Oakdale West Estate Modification 7

Changes to Precincts 3 and 4 including earthworks, retaining walls, building layouts in Precinct 4 and estate road 7
State Significant Development Modification Assessment (SSD-7348-Mod-7)

October 2021

Published by the NSW Department of Planning, Industry and Environment

Figure 5 | Changes to earthworks and finished floor levels (comparison of MOD 6 and MOD 7)

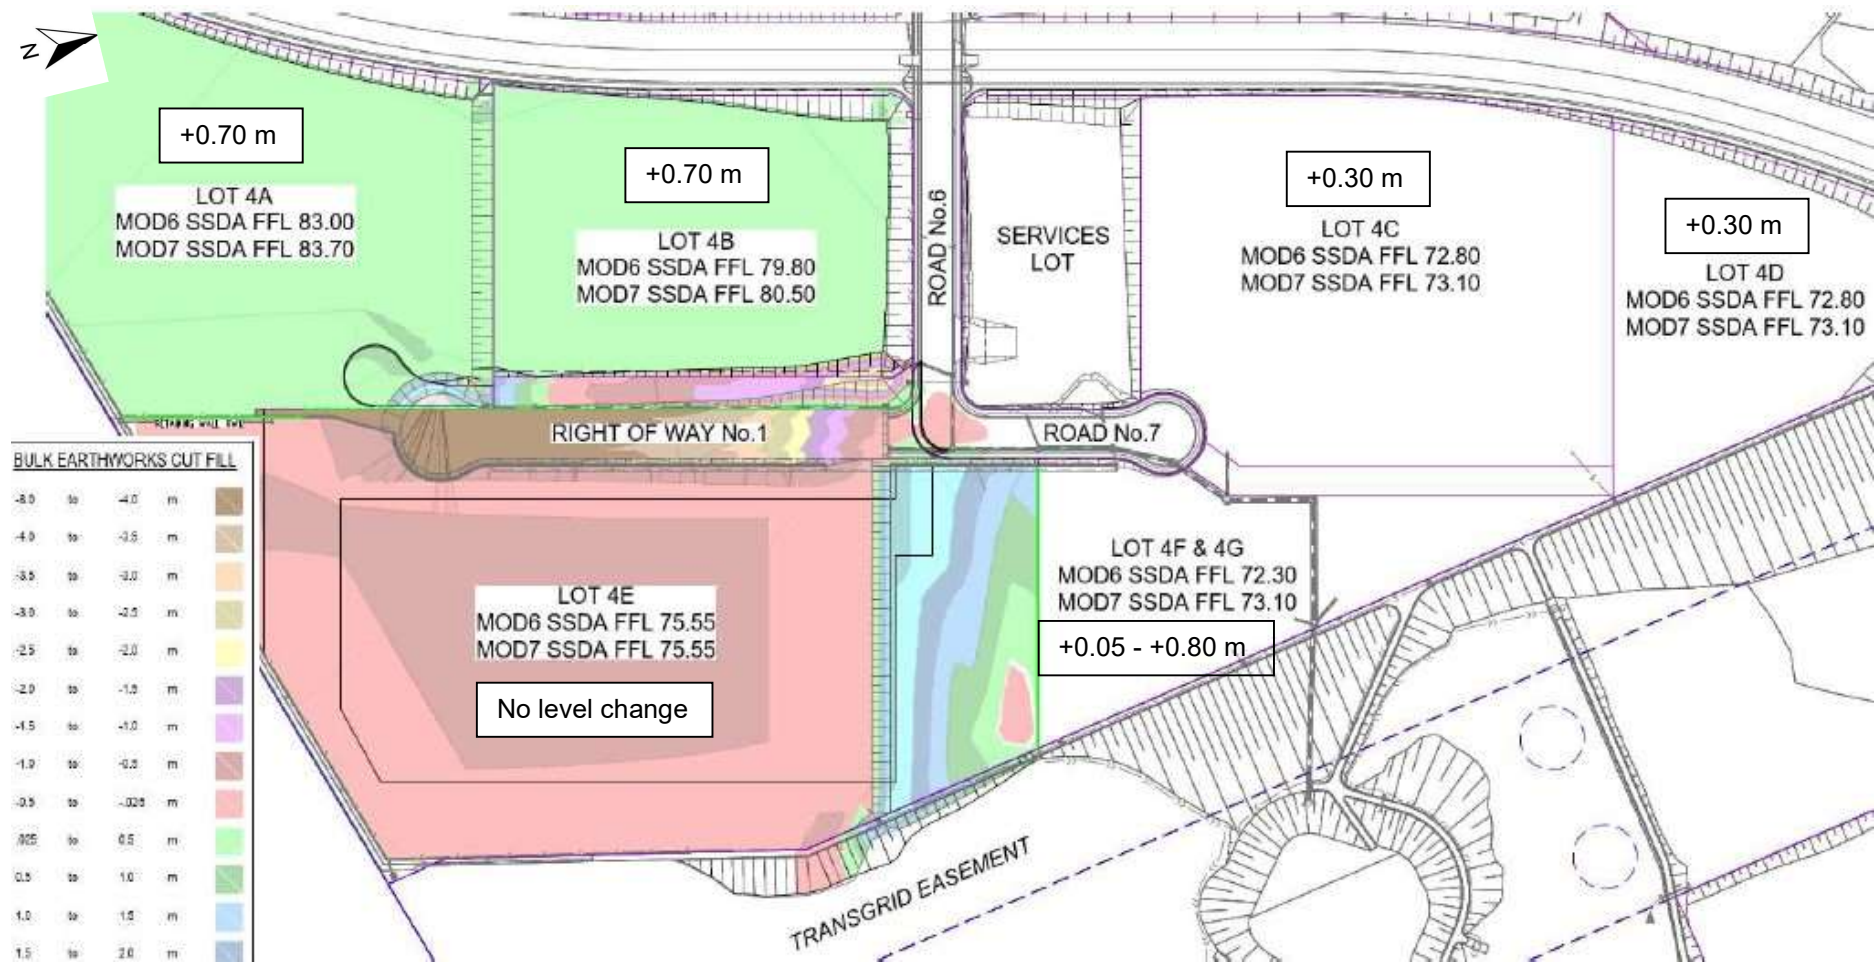
Aspect	Description
Modifications to Concept Proposal	
Precinct 4	<ul style="list-style-type: none"> minor changes to approved earthworks levels for lots 4A and 4B (+0.70 m), lots 4C and 4D (+0.30 m), lot 4F (+0.05 m) and lot 4G (+0.80 m) alterations to building 4E layout and area, increased lot size and additional car parking (no change to approved earthworks level) increase gross floor area in Precinct 4 by 55 square metres (m²) relocate buildings 4F and 4G to the north and reduce the footprint to accommodate the increased area of building 4E remove part of estate road 7 to accommodate building 4E and insert a private right-of-way to buildings 4A and 4B increase development area by 0.7 ha in Precinct 4 remove restriction on the night-time use of forklifts at building 4E
Precinct 3	<ul style="list-style-type: none"> minor change to the boundary between lots 3B and 3C to move it further south to accommodate changes to building 3B (changes to building 3B being assessed under separate development application with Council) extending the approved earthworks pad for lot 3B further south to increase the lot size, with a corresponding reduction in lot size for 3C. There is no change to the approved earthworks levels decrease gross floor area in Precinct 3 by 55 m²

Modifications to Stage 1 Development	
Precinct 4	<ul style="list-style-type: none"> bulk earthworks to increase the approved pad level for building 4E construction of retaining walls between lot 4E and lot 4A and 4B
Precinct 3	<ul style="list-style-type: none"> bulk earthworks to increase the approved pad level for building 3B construction of retaining walls between lot 3B and 3C
Precinct 1	<ul style="list-style-type: none"> construct a 2.4 m high fence on the lot boundary between building 1A and buildings 1B and 1C
